Review of Hydrogeological Assessment - Proposed Geelong Resource Recovery Facility

The Golden Plains Shire Council (Council) required that a Hydrogeological Assessment (HA) be carried out to support a Planning Permit Application for a new waste management facility to be located approximately 13 km west of the Geelong City Centre - the proposed Geelong Resource Recovery Facility (GRRF). The Hydrogeological Assessment was prepared by SMEC in August 2015

Council engaged AECOM Australia Pty Ltd to undertake a review of the HA and we proposed to address these specific questions:

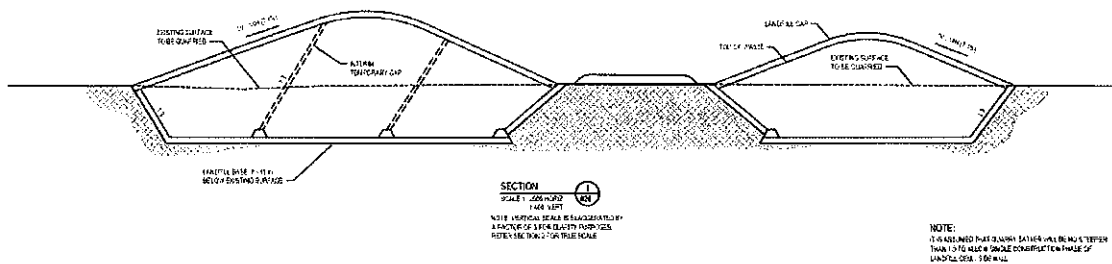
The Groundwater Contamination Assessment (Section 5 of the HA) provides an assessment of contamination of the site as it is now, not as a consequence of its intended use. The report indicates there are issues with using the older bores from the site (windmills and quarry exploration bores) for development of the hydrogeological conceptual model and as a consequence it proposes cleaning out of the existing bores and drilling of 4 additional bores in the Newer Volcanics. A recommended quarterly monitoring program is proposed. Note that the plan of new bores (Figure 5-1) shows eight new monitoring bore locations.

If the proposed development is approved, the existing bores could not be incorporated into the regular monitoring program because of lack of bore construction information. So the proposed drilling of at least eight new bores would be required and we concur with the proposed locations.
